Re: Aurora Crossroads (#1416252)/Pre-Application Meeting held November 07, 2019

Thank you for taking the time to review the Aurora Crossroads Pre-Application Meeting held on November 7, 2019 along with City Staff. Valuable feedback was received on November 22, 2019. Responses to comments are detailed on the following pages. Please feel free to reach out should you have any questions by phone, at 303-892-1166 or by email, awenlund@norris-design.com

Figure 4.5-1: Major Road Connectivity

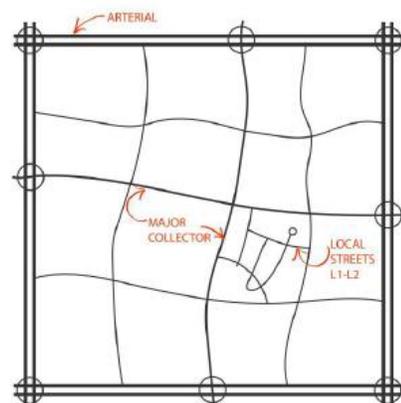
All lots must have direct access to a dedicated public or private street. Alternative “indirect access” configurations such as green court dwellings, or motor court dwellings are not permitted in this zone district. In addition, block perimeters are limited to 2,800 linear feet with a maximum length of any block face of 700 feet. With the conceptual street network shown with the pre-application submittal, additional streets will need to be created to meet these requirements. Any townhomes proposed are required to front a street. Mixed Used zone districts have additional access and connectivity requirements (UDO Section 146-4.5.4).

Response: Noted, this level of information will be included with the second MP submittal
